**HIGHLANDS COUNTY  
BOARD OF COUNTY COMMISSIONERS  
(HCBCC)  
PURCHASING DIVISION**

BID NO. ITB 19-005 ADDENDUM No. 5

Project: 19-005 Sebring Parkway Phase IIA Project No. 17062- #429841-1-54-01,  
Sebring Parkway Phase IIB Project No. 17063- #433553-1-54-01, and  
the City of Sebring Utility Modifications

This addendum is being issued to revise the Bid Form Part 1, Bid Form Part 5, plan set sheets T-2 & T-5 and address questions received.

SHEET NUMBER  
T-5

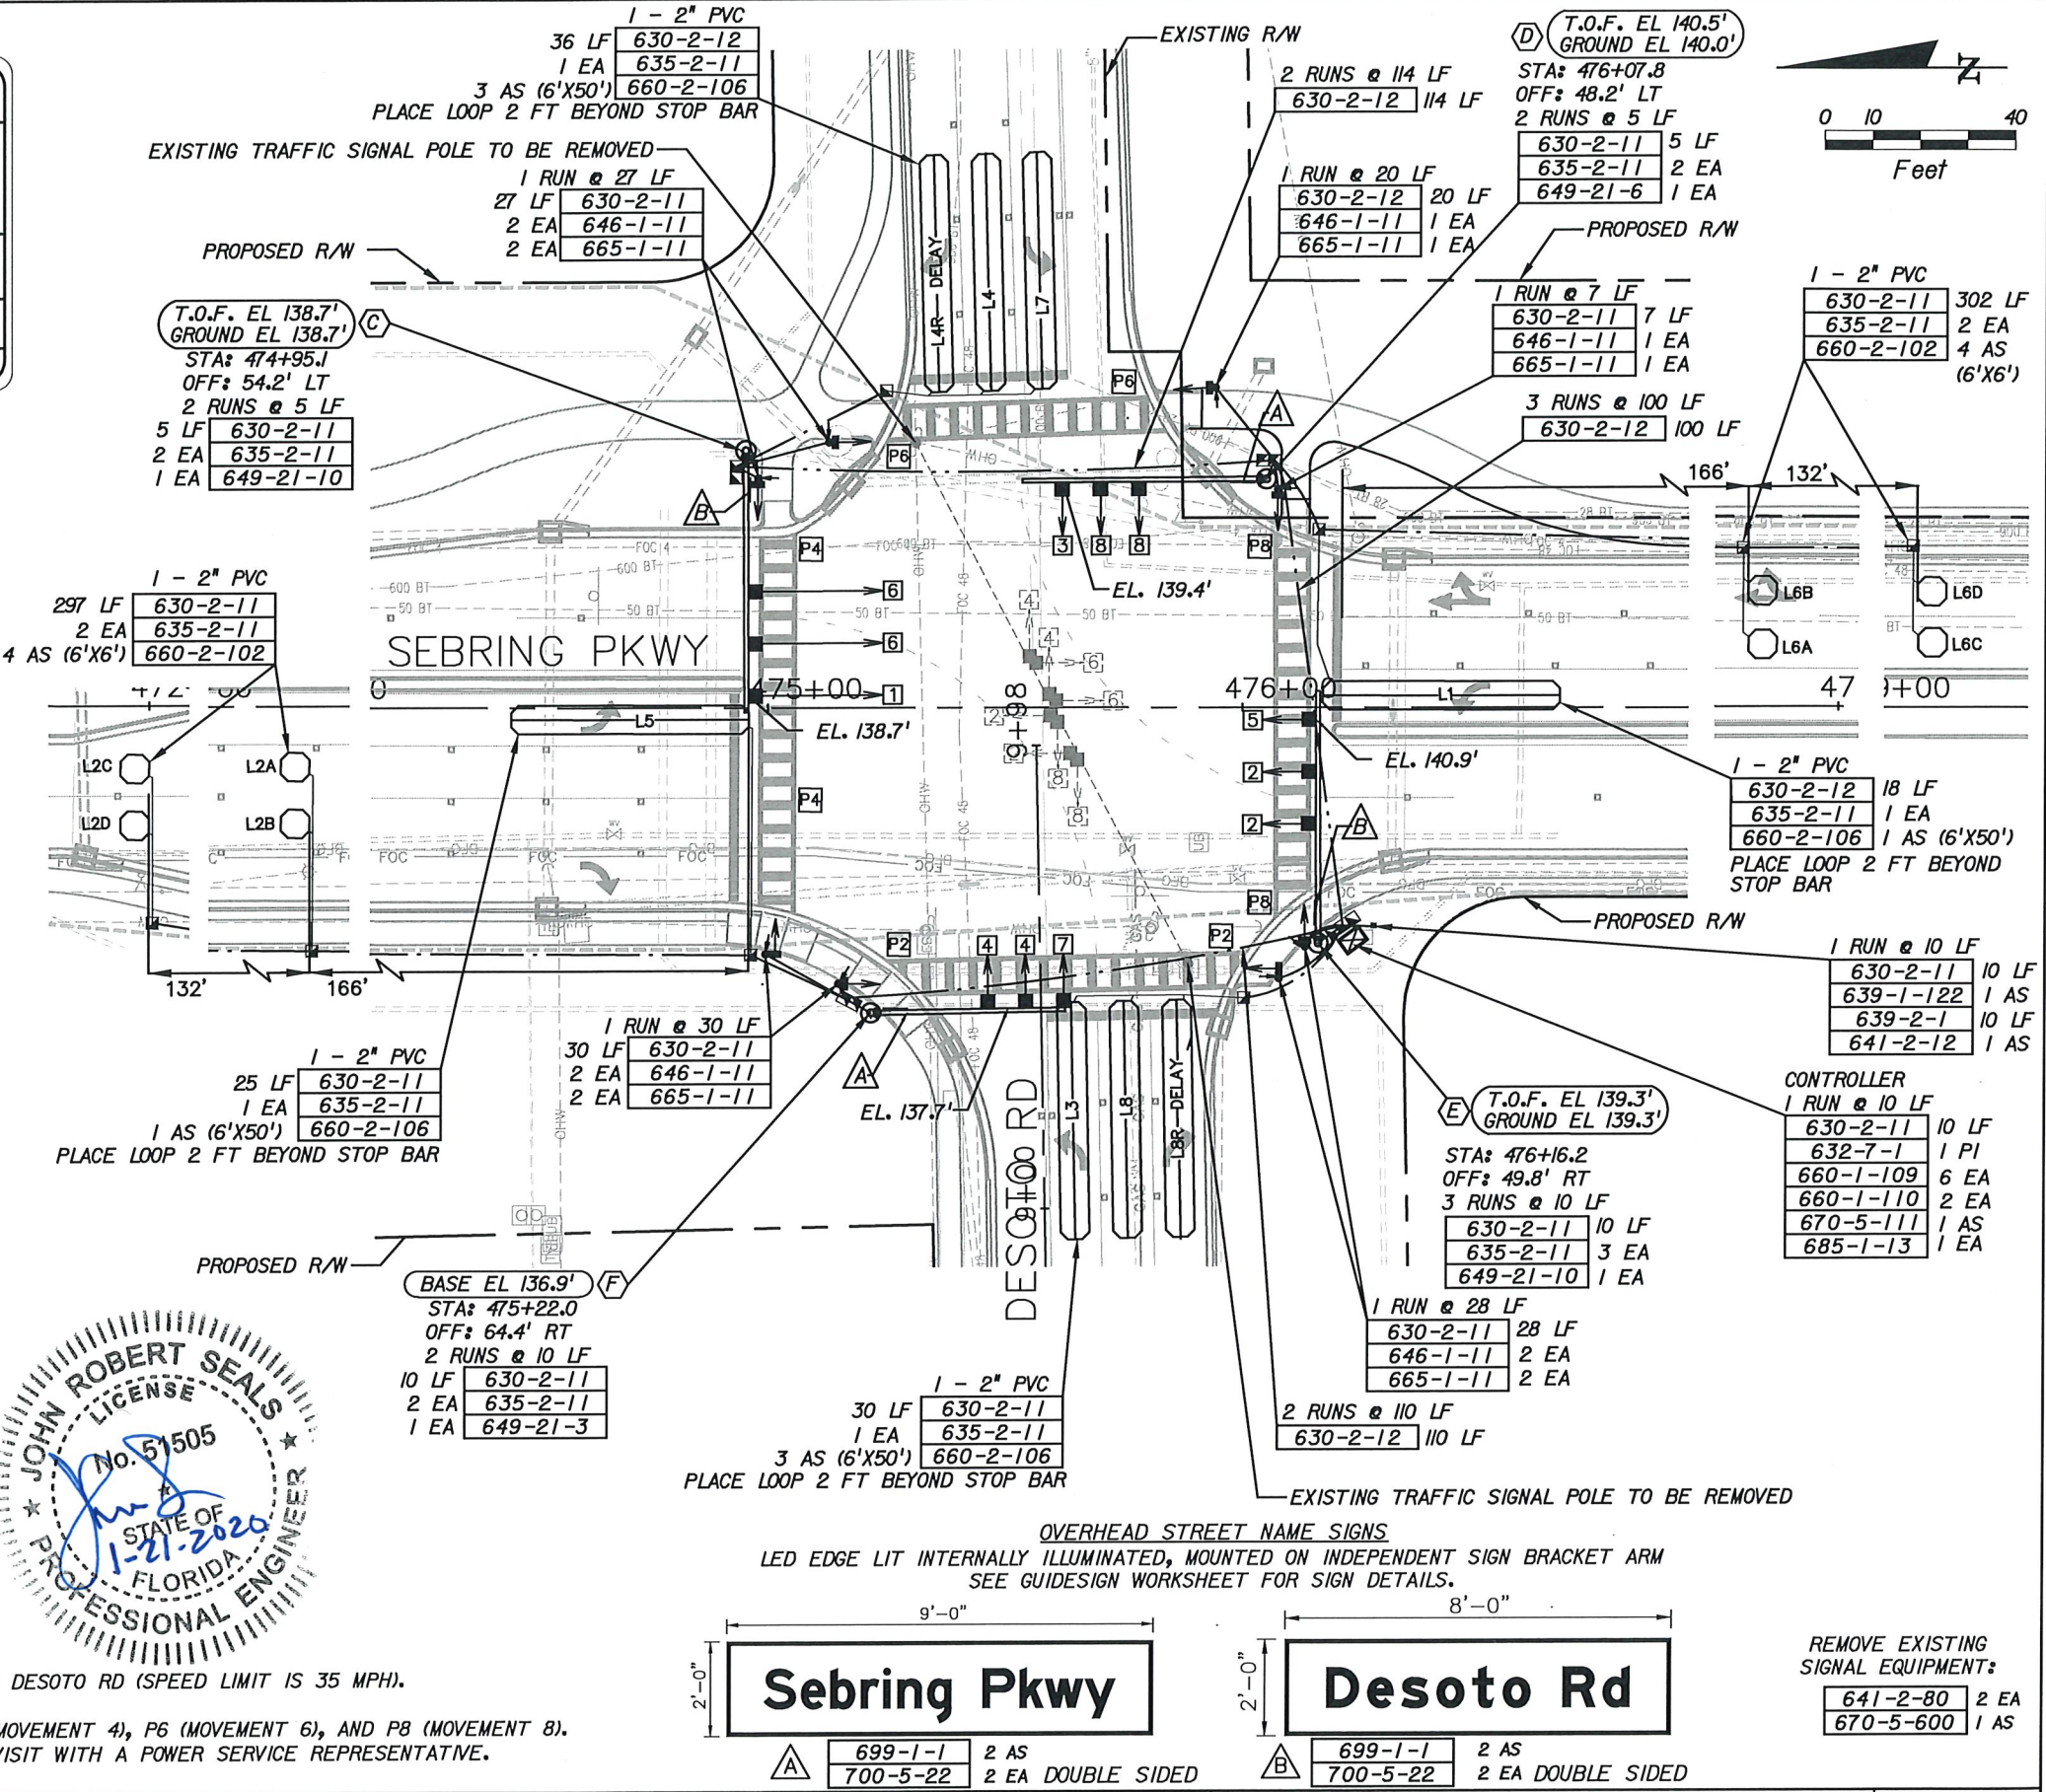
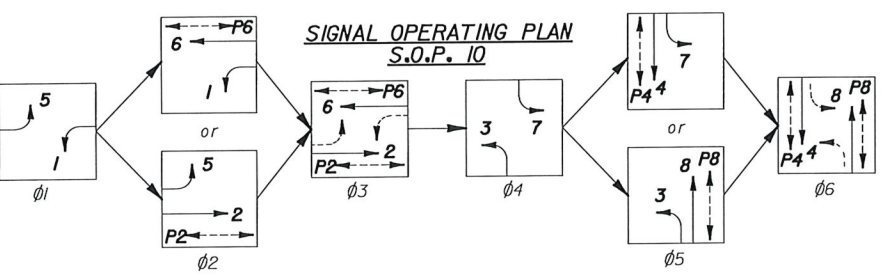
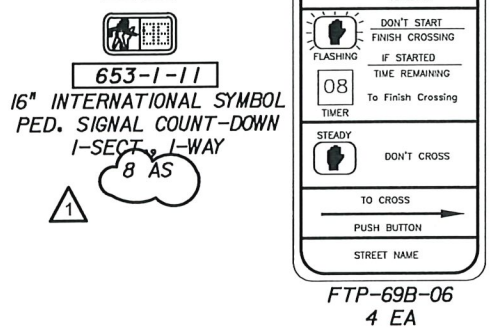
3. See revised plan set sheets T-2 and T-5 by Kimley-Horn revising the quantity for Item No. 653-1-11 on Sheet T-2 to 8. See Attachment C.

7. There 4 pedestrian signals on plan sheet T-5 but it would appear 8 are required as there are 8 aluminum poles and 8 pedestrian detectors...see tabulations on plan sheet T-2.

**Answer: Item No. 653-1-11 on Sheet T-2 is incorrect. The quantity for Item No. 653-1-11 on Sheet T-2 should be 8. Please also see revised Bid Form #1, Item 90 has been revised from 6 to 10 EA. See Revised Plan Sheets -Attachment C.**
